THE CORPORATION OF THE CITY OF KAWARTHA LAKES

PW- 2012-001

Subject: Proposed ATV Route Through Lindsay

Appendix 5 – Comments received from Lindsay Police Service

# Access point at Thunder Bridge Rd

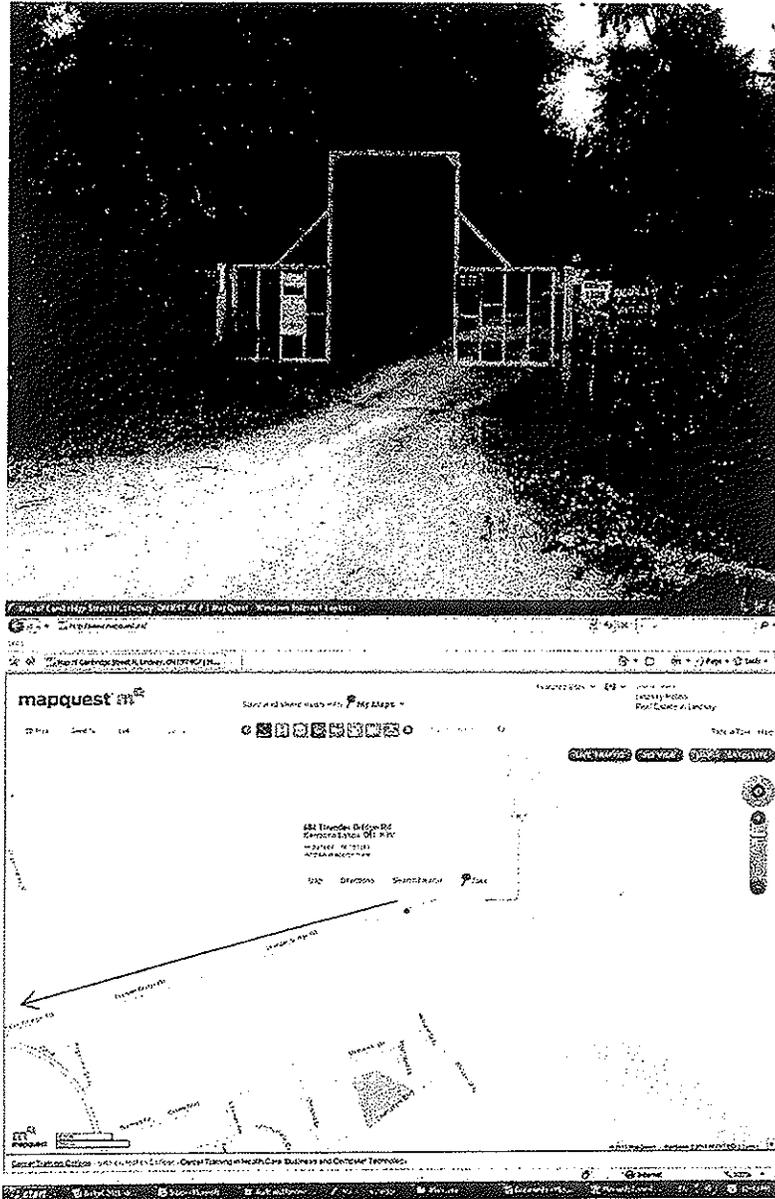
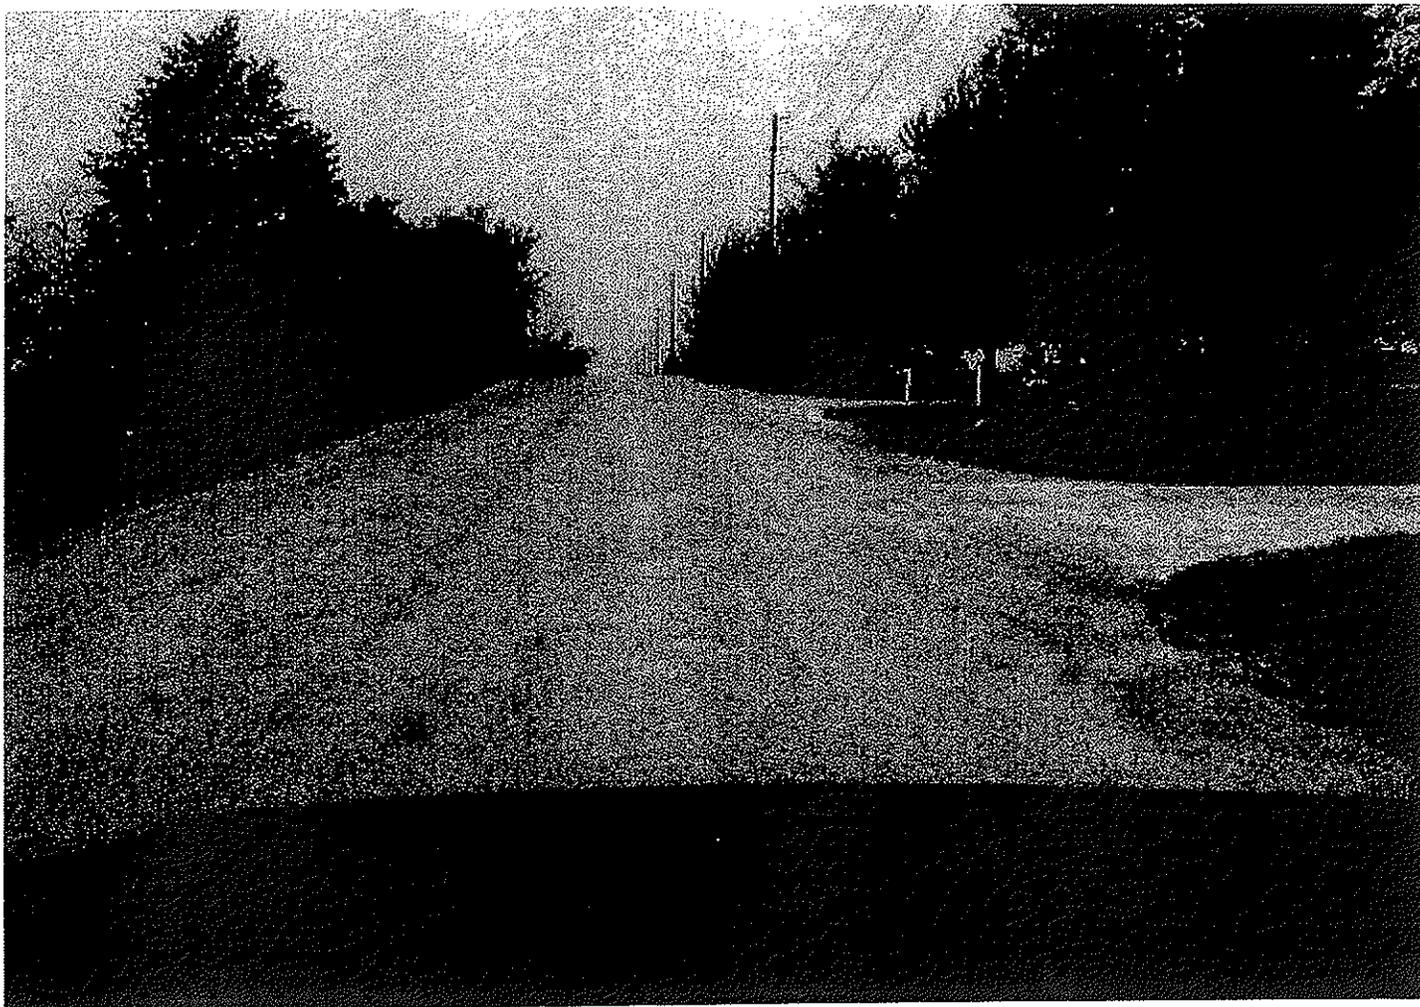
Thunder Bridge Rd. - "grassed" narrow shoulders;

Area	Safe	Borderline	Unsafe
At the access point, Thunder Bridge Rd is narrow without gravel shoulders		X	
Once past Angeline St. N. it opens up with nice gravel shoulders on both sides	X		
The intersection at HWY 35 is reasonably flat with good sight lines	X		
Turning at Monarch Rd I noticed a tractor being passed (legally) showing the safe multi use of the road	X		
Monarch Rd is narrow with "grassed" shoulder and mailboxes right at the asphalt		X	
Crossing HWY 7 at Monarch is not ideal, no lights, significant slope		X	
Monarch Rd past Dew Drop Inn is gravel, narrow and multi use (tractor again)		X	
Entrance to Little Britain Rd is OK but entering at 80 km/h zone		X	
Little Britain Rd is nice and wide, good shoulders	X		
The intersection at HWY 7/35 is busy, not ideal with East bound traffic partially obscured with the curve		X	
Angeline St. S begins with 3 lanes, dangerous for ATV traffic, then no shoulders			X

# Thunder Bridge Rd @ Monarch Rd

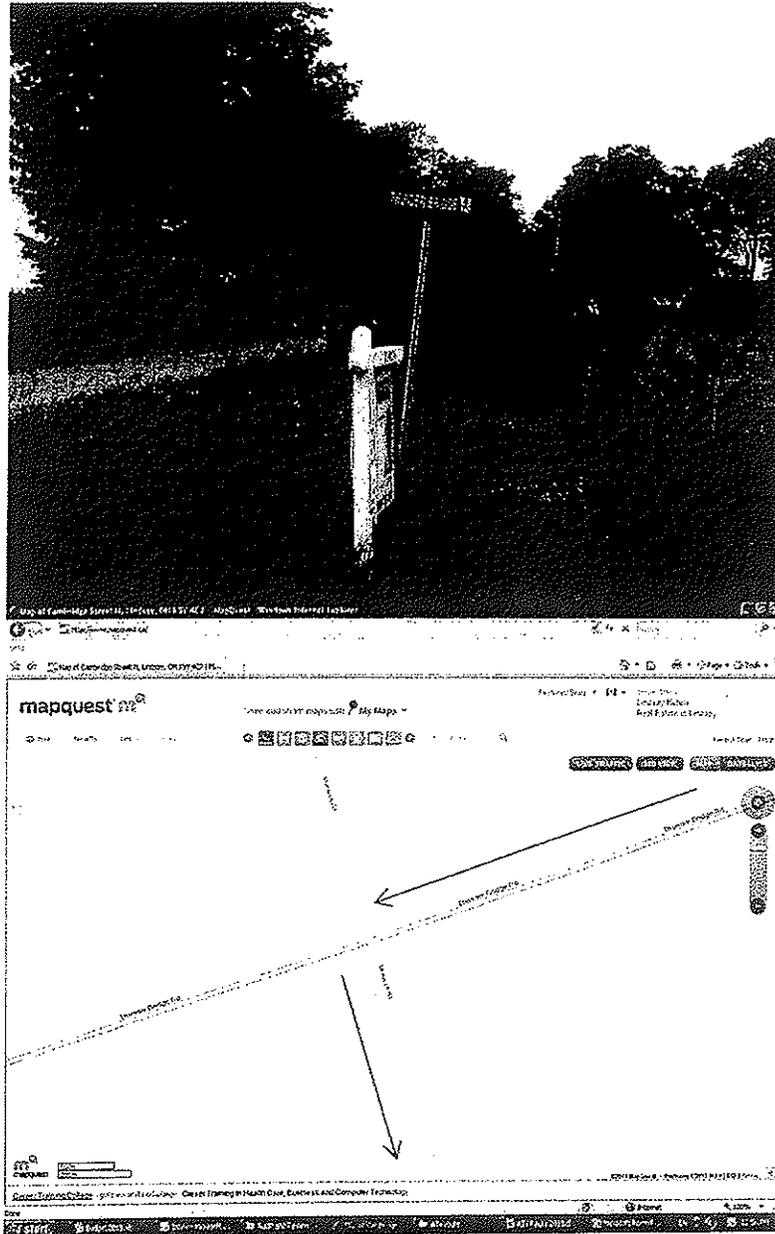
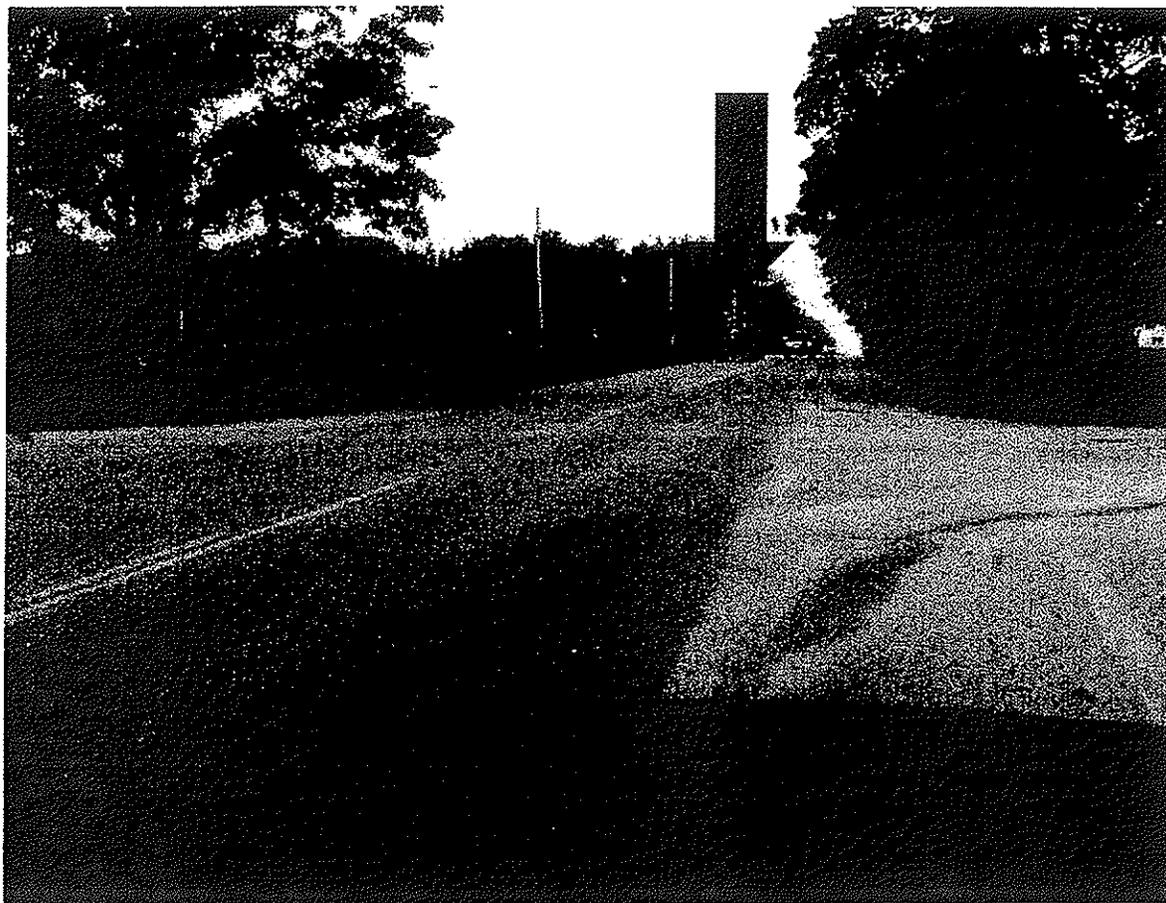
Tractor being passed by a vehicle east bound Thunder Bridge

Monarch Rd narrow, with "grassed" shoulders

Another picture of Monarch showing mail boxes at road

# Monarch Rd @ HWY 7

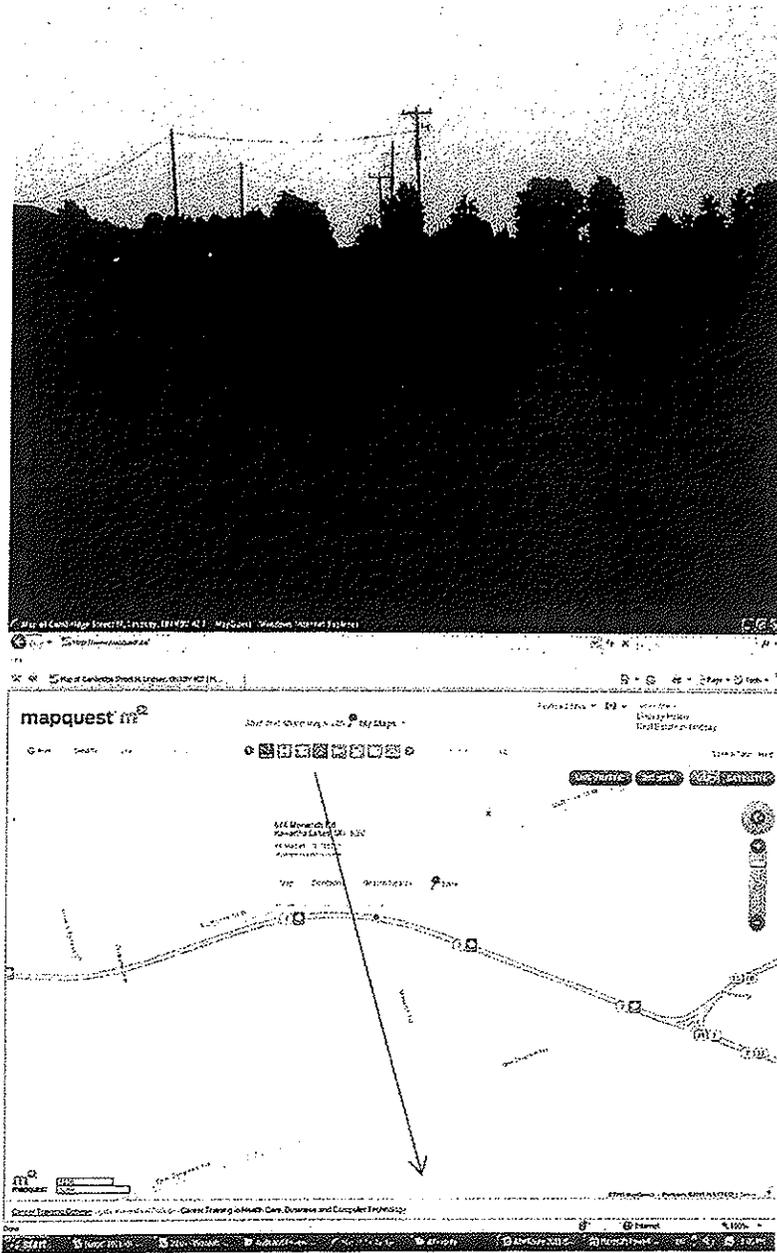
It appears that a crossing is proposed across Highway 7 in the vicinity of Monarch (see attached sketch). MTO has safety concerns with this proposal and is not prepared to endorse this location. As you are aware, this section of Highway 7 is planned for four laning in the future and with the additional lanes and highway speeds at this location, MTO would not be prepared to support a crossing at this location.

# Monarch Rd @ Dew Drop Inn Rd

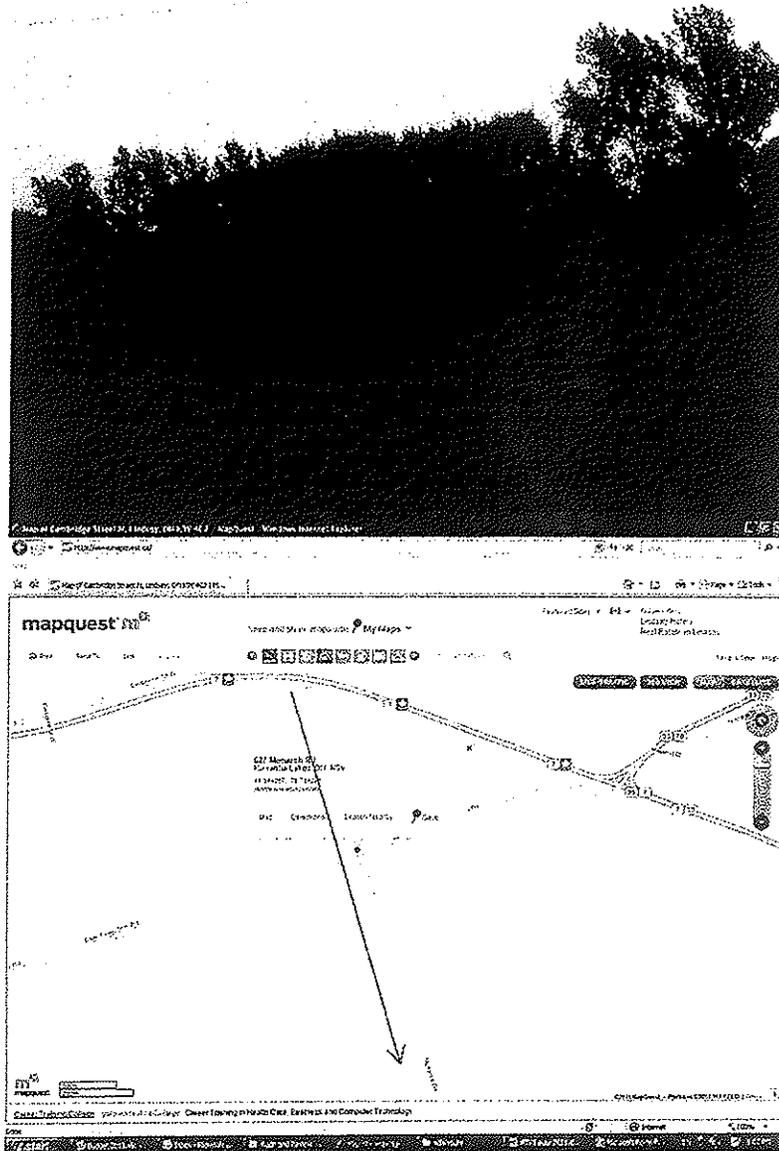
Monarch Rd is now gravel, narrow, no shoulders & multi use

# Monarch Rd @ Little Britain Rd

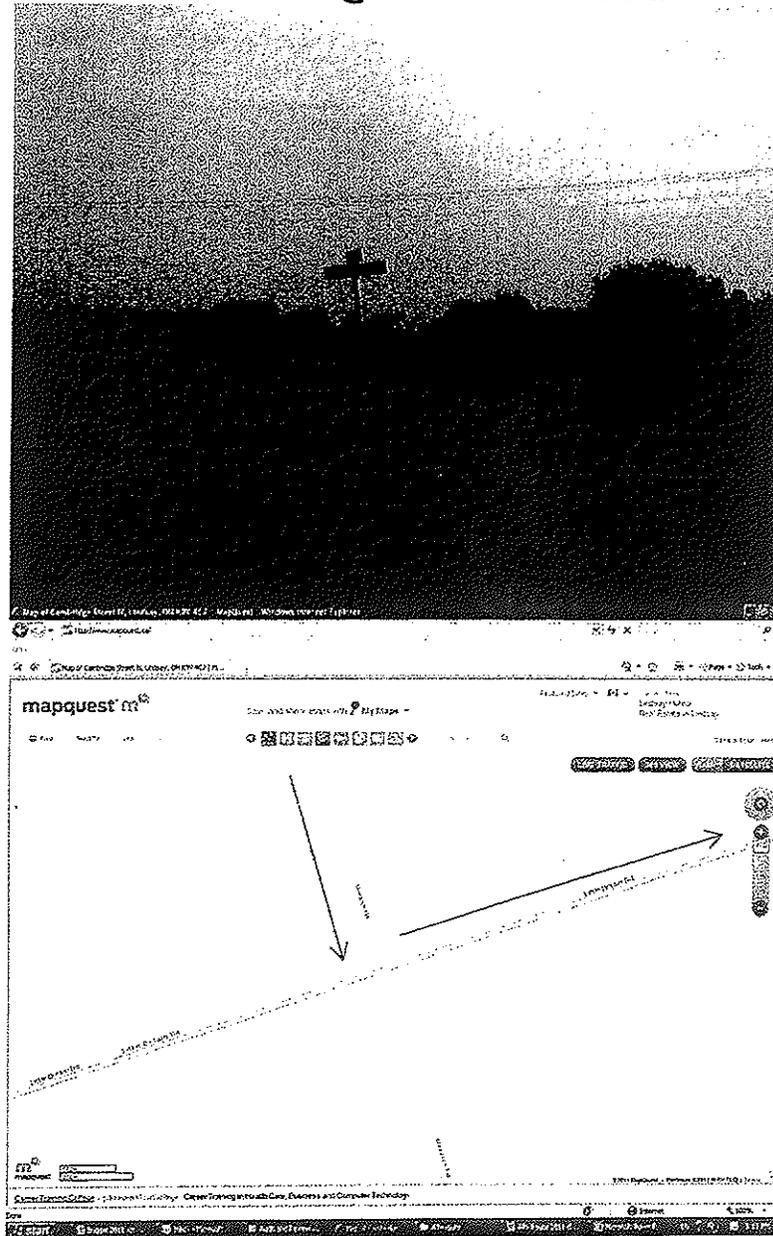
Wide shoulders, 80 km/hr zone

# Little Britain Rd @ HWY 7/35

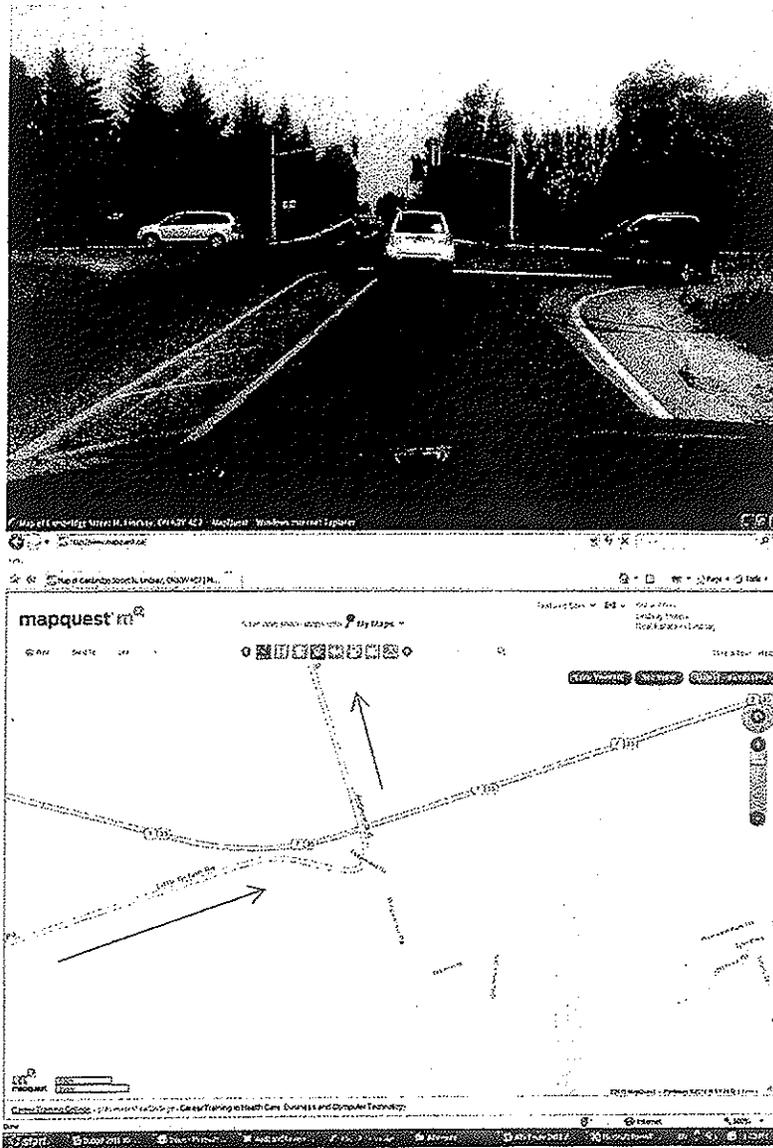
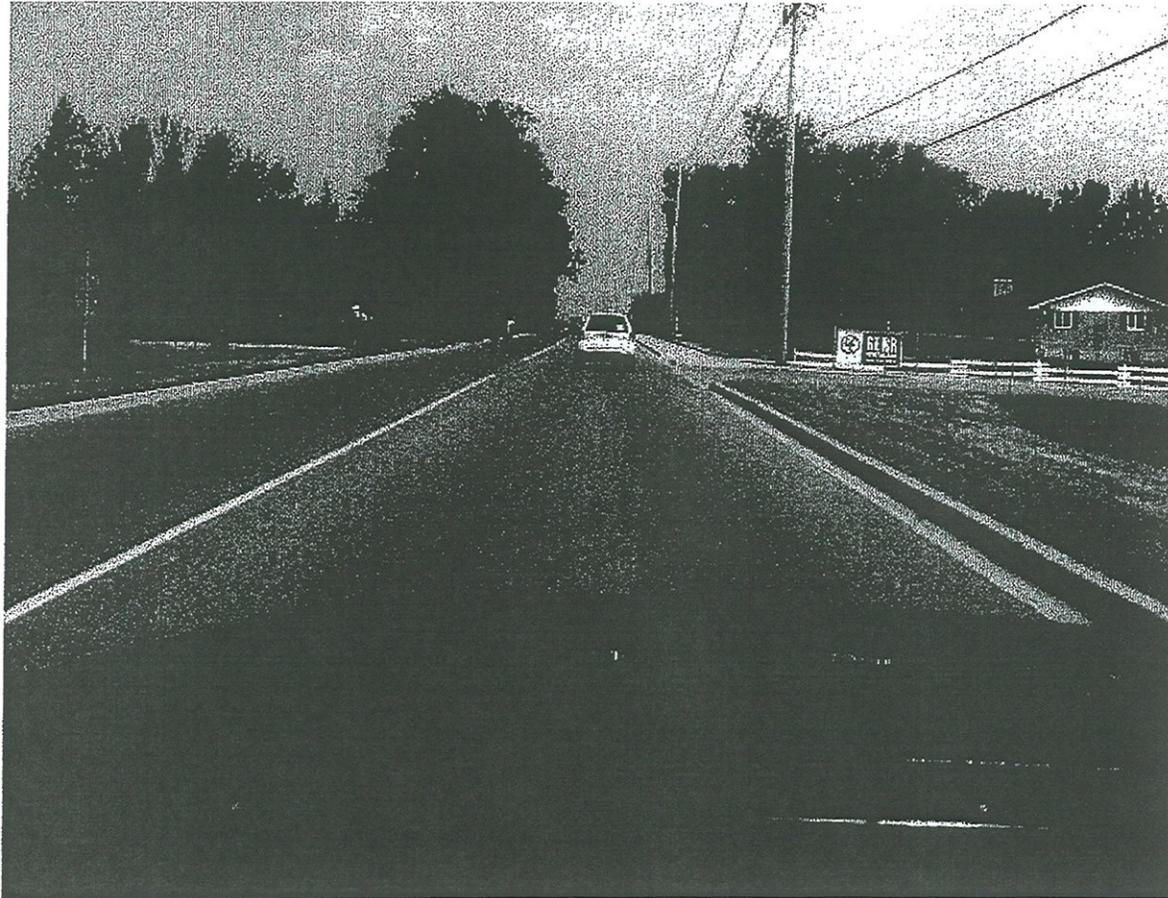
Angeline St S., no shoulders, passing High School
